## Product Change Notice (PCN)

PCN Number: **PCN-0456243R-01**

Product(s) Affected: **SJ1-353XNS series. SJ1-3533NS, SJ1-3534NS & SJ1-3535NS**

PREVIOUS CUI DETAIL/IMAGE	NEW CUI DETAIL/IMAGE

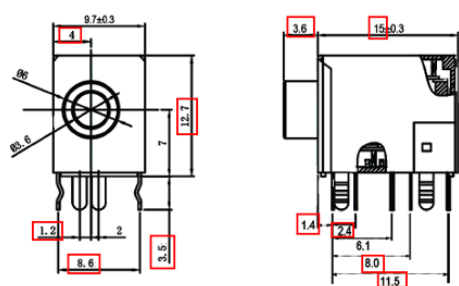
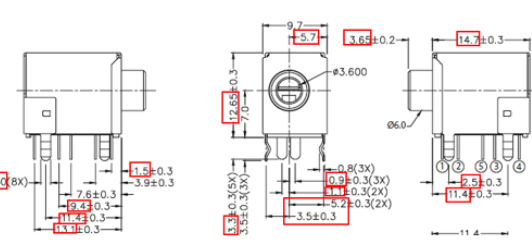
Description of Change: *New Factory Location. Product re-engineered for improved manufacturability and production yield. See image below for reference and check CUI Devices website for updated drawing. Cosmetic differences may be visible but will not affect the form fit and function of the product.*

PREVIOUS CUI DETAIL/IMAGE			NEW CUI DETAIL/IMAGE		
DESCRIPTION	MATERIAL	PLATING/COLOR	DESCRIPTION	MATERIAL	PLATING/COLOR
terminal 1	brass	silver	terminal 1	brass	tin
terminal 2	phosphor bronze	silver	terminal 2	brass	tin
terminal 3	phosphor bronze	silver	terminal 3	brass	tin
terminal 4	brass	silver	terminal 4	brass	tin
terminal 5	brass	silver	terminal 5	brass	tin
spring	stainless steel	nickel	spring	stainless steel	
bushing	brass H59	nickel	bushing	brass	nickel
shield	SPCC t=0.30	nickel	shield	cold rolled steel	nickel
housing	PBT (UL94V-0)	black	housing	PBT (UL94V-0)	black
